Project No. 12091-01

Subject: Preliminary Geotechnical Evaluation and Response to City Review Comments for Proposed San Pedro Distribution Center, 1599 W. John S. Gibson Boulevard, Los Angeles, California

5.0 RESPONSE TO CITY REVIEW COMMENTS

SHEET
3 of 5

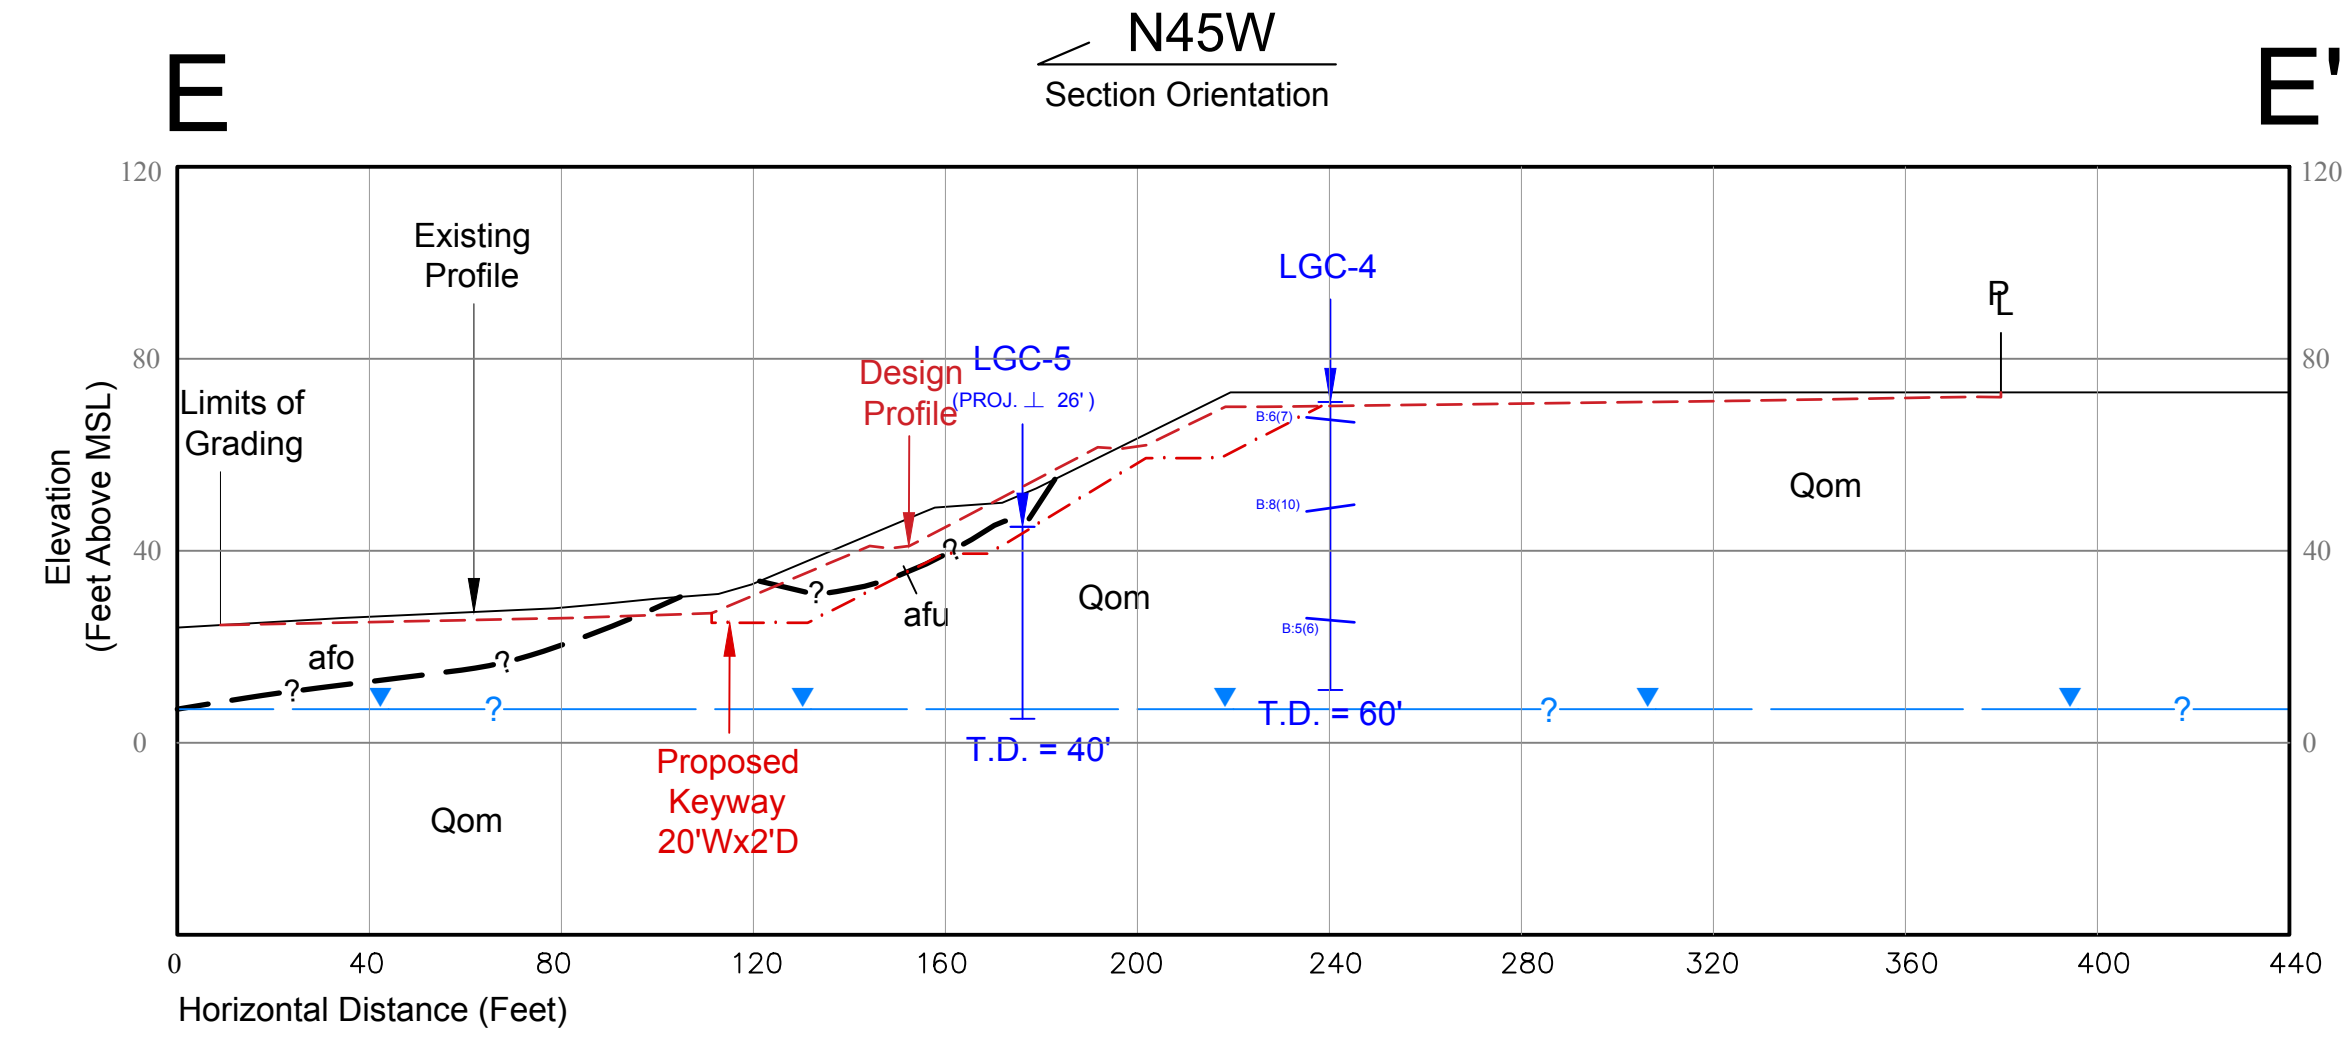
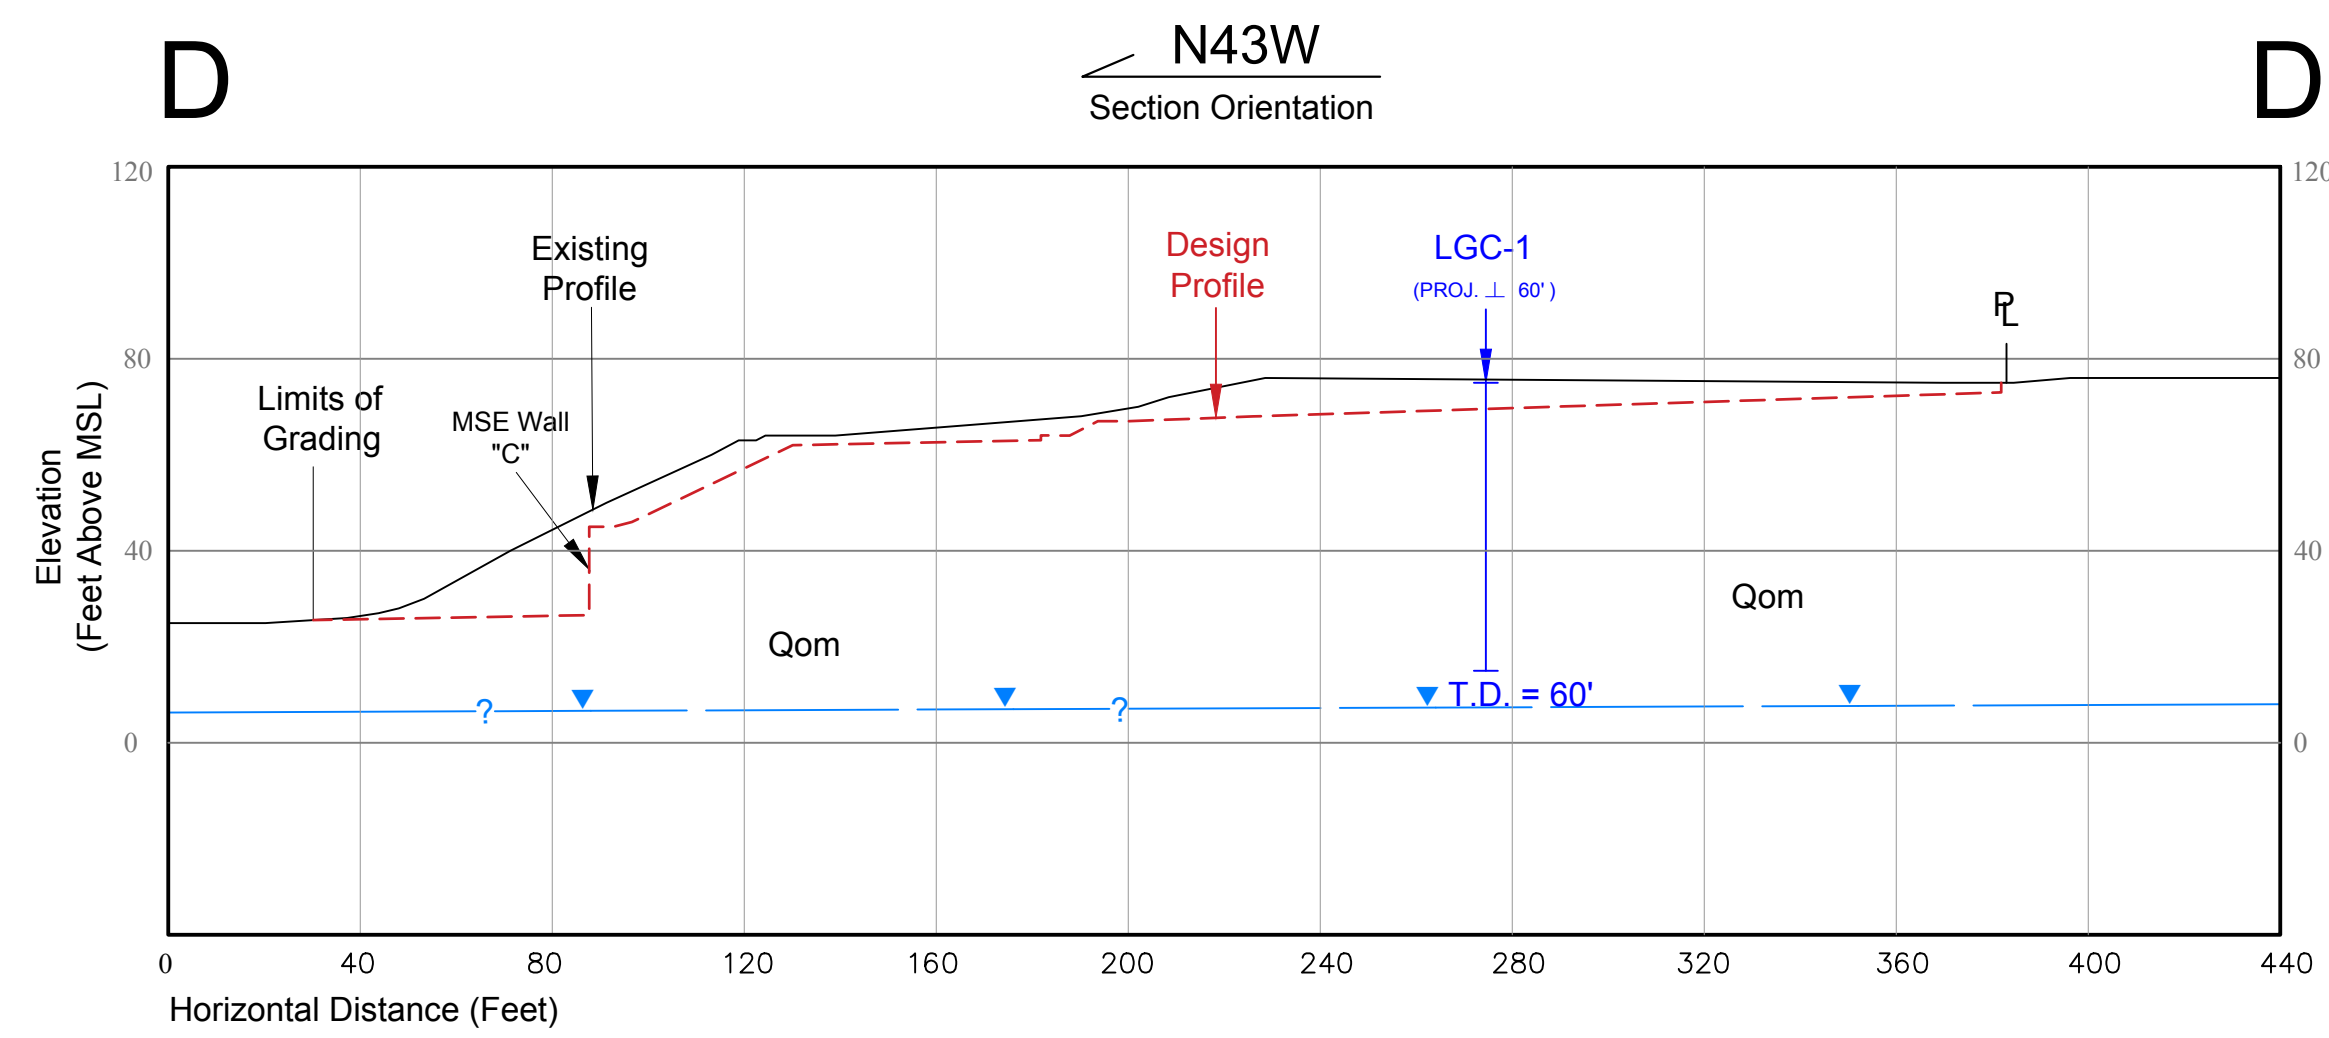
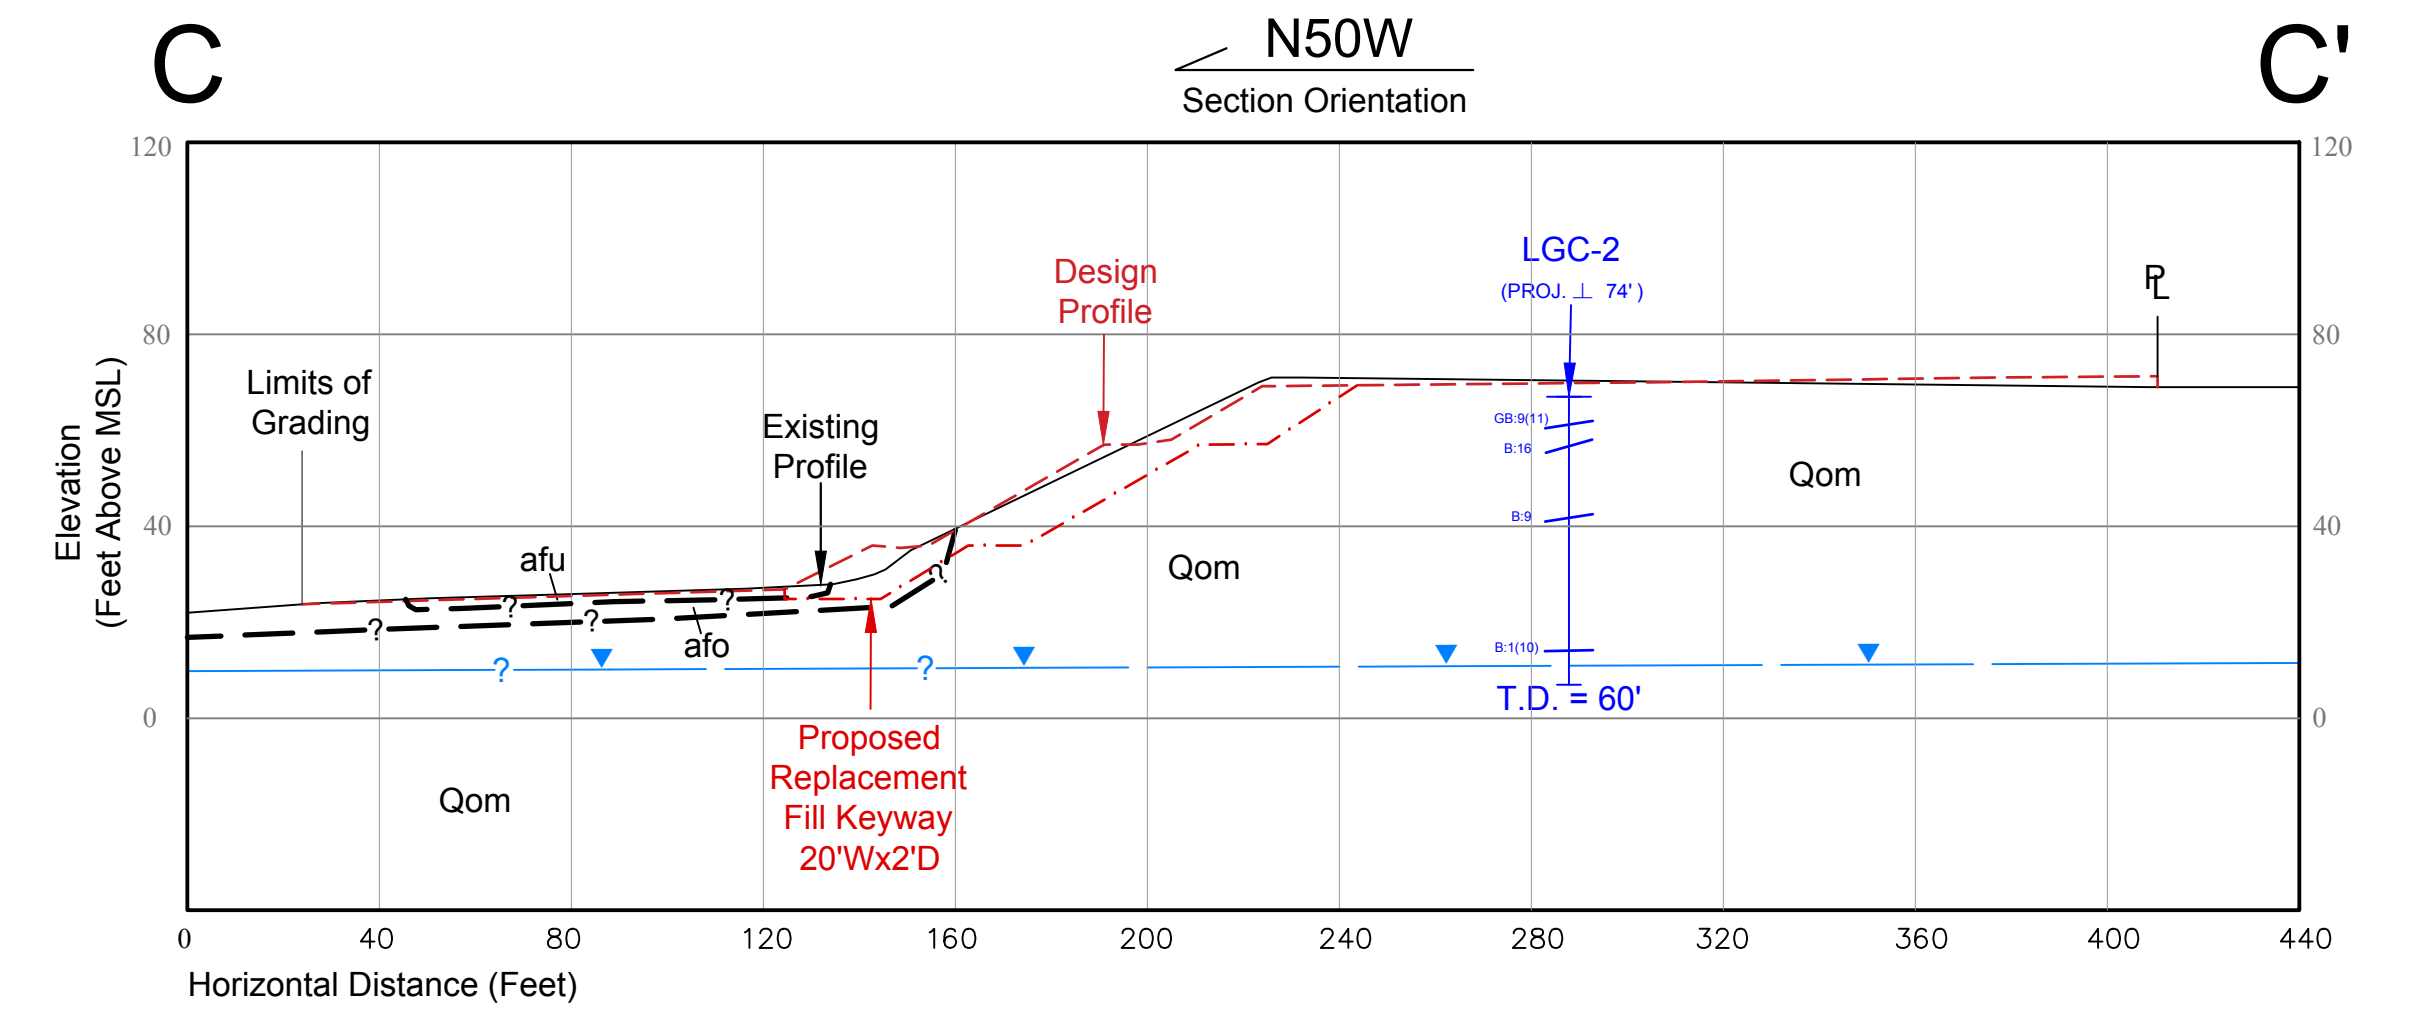
“Provide a geologic map and cross sections that are based upon conceptual grading or site development plans, to illustrate all proposed and existing contours relative to the planned grading and/or construction, along with all off-site slopes and conditions that could adversely affect the stability or safety of the site (7006.3.2). The geologic map and cross sections shall depict the top and bottom of slopes; lithologic contacts; bedding attitudes; locations of slumps, landslides, or faults relative to the subject site; existing and proposed topographic profiles; existing and proposed structures; and, required Code setbacks. (7006.3.2)”

“Provide geological cross sections illustrating existing and proposed grades and structures through the highest, steepest and geologically critical slopes.”

Refer to the attached Geotechnical Map and Geotechnical Cross Sections (Sheets 1 through 5). No building structures are planned for the site.
